# UNITED STATES PATENT AND TRADEMARK OFFICE

10/734,717

<b>Office Action Summary</b>	<b>Application No.</b> 10/734,717	<b>Applicant(s)</b> BEDINGHAM ET AL.	
	<b>Examiner</b> Robert R. Raevis	<b>Art Unit</b> 2856

### DETAILED ACTION

EXHIBIT  
"A"

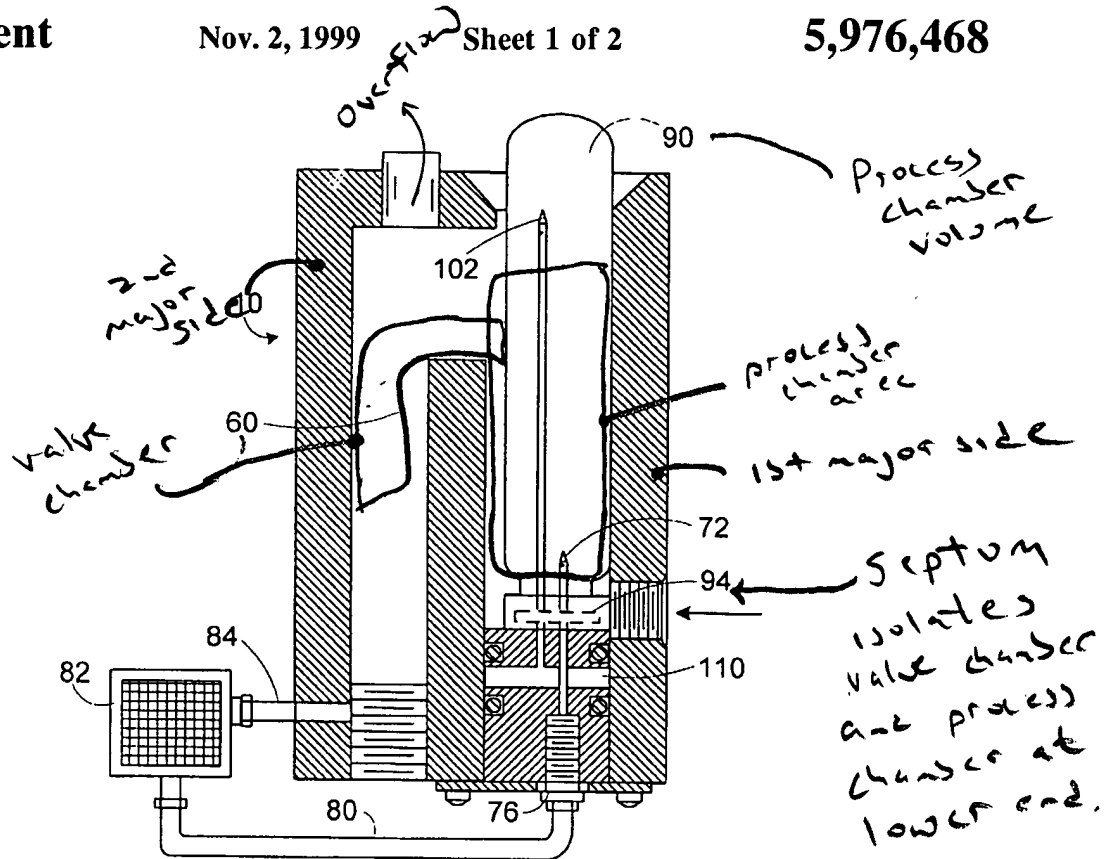
Godec et al teach (Figure 2; See Exhibit "A", taking care to following the penciled lines, leads and labels) valved process chamber on a sample processing device, the valved process chamber including: process chamber 90 having a volume between right and left hand external walls of "rectangular" (col. 6, line 44) housing 10, the chamber occupying an process chamber area (between right hand external wall and vertically extending mid wall), and the area having a length (height) and width; a valve chamber 60 located within the process chamber area, the valve chamber located between the

process chamber volume 90 and the left hand side of the processing device, where the valve chamber is isolated from the process chamber by a septum 94 separating the valve chamber and the process chamber, and where a portion of the process chamber volume lies between the septum 94 and the right hand external wall. The chamber is typically a "test tube" (col. 8, line 17), which passes electromagnetic energy there through, permitting liquid level to be seen as it leaves the container.

As to claims 3,5, the wall on the right-hand side of volume 90 may be deemed to be a major side. Also, the chamber 90 is inside the container external wall, and thus mutually exclusive.

As to claim 8, septum 94 appears to be 1 mm thickness.

FIG. 1

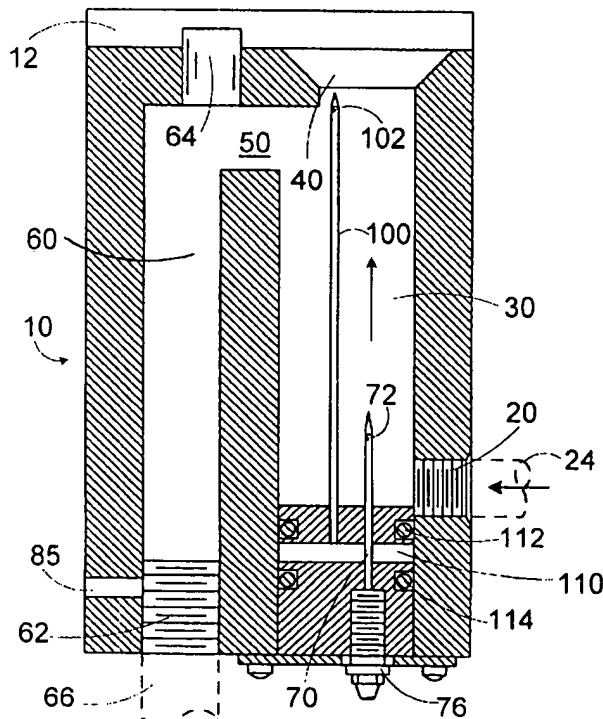
As to p. 10, second full para; the shorter needle of Figure 1 of Godec would seem to form an opening in the septum 94 along the length of the process chamber, the location of which is related to the level of the sample liquid in the container. Note the Godec does identify the sample as liquid in his claim 12.

EXHIBIT  
"B"

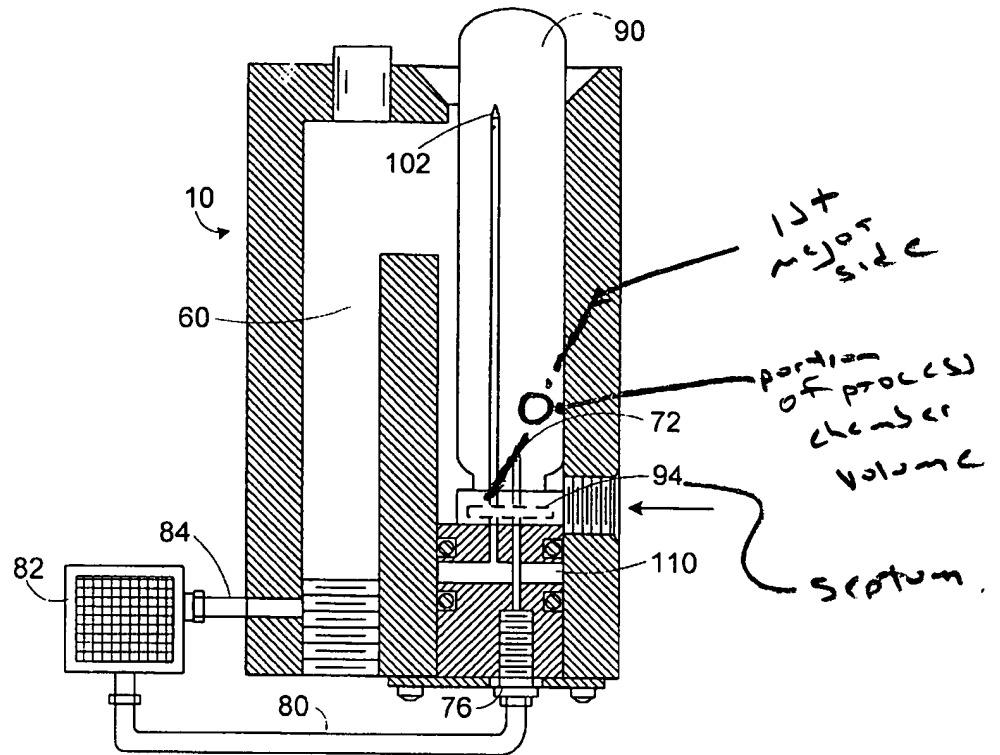
As to p. 10, first full para; please see Exhibit “B”, which illustrates a “portion” (designated by the circle) of the process chamber volume located between the septum and first major side.
